Topic: Cage Compatibility with R2100 Blades
Component(s) Affected: R2100 Dual Xeon Workstation Blades, R-Series Cage
Date: January 12th, 2002

Figure 1 Early Cage with Long Dividers

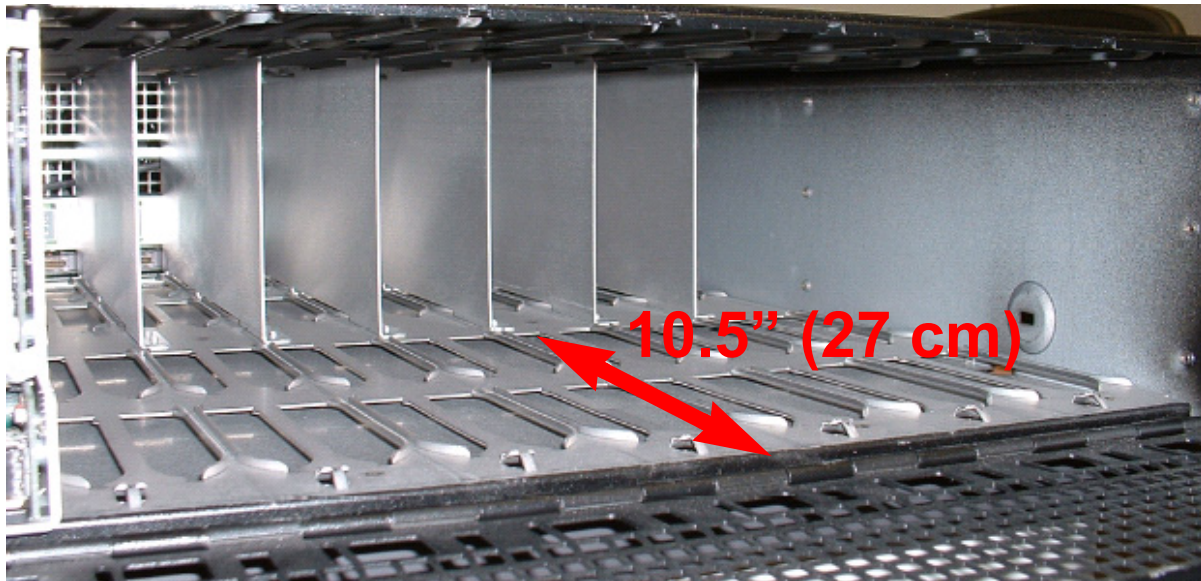
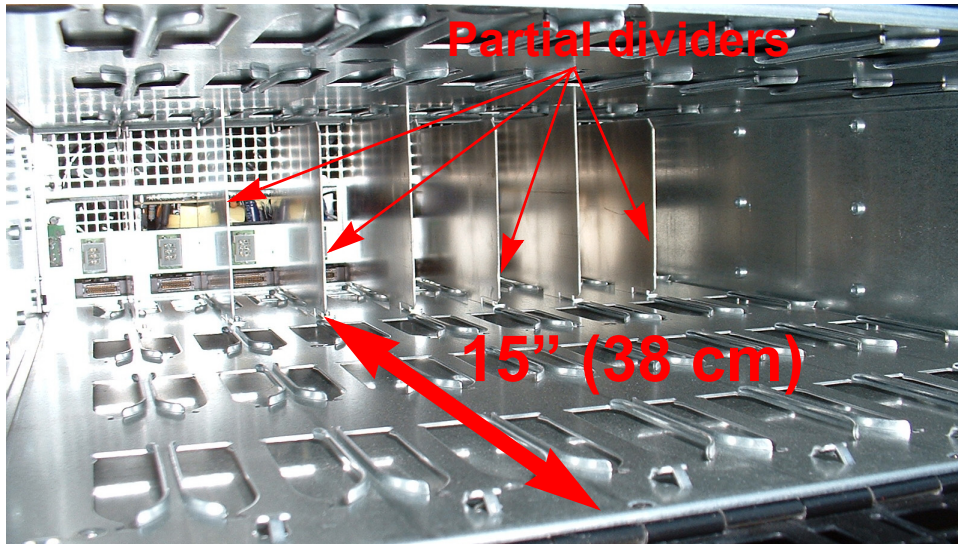
To check for proper compatibility, measure the distance between the front of the Cage and the front of the dividers. The Cage shown below was manufactured prior to May 2002 (EC120). The front edges of the dividers are approximately 10.5 inches from the front of the Cage every divider extends all the way to the top cover. These Cages *will not* accommodate R2100 Blades.

The Cage below was manufactured after May 2002 (EC120). The front edges of the dividers are approximately 15 inches from the front of the Cage and every other divider does not fully extend to the top cover. These Cages *will* accommodate R2100 Blades.

Verify compatibility prior to installing a R2100 Blade in a Cage.
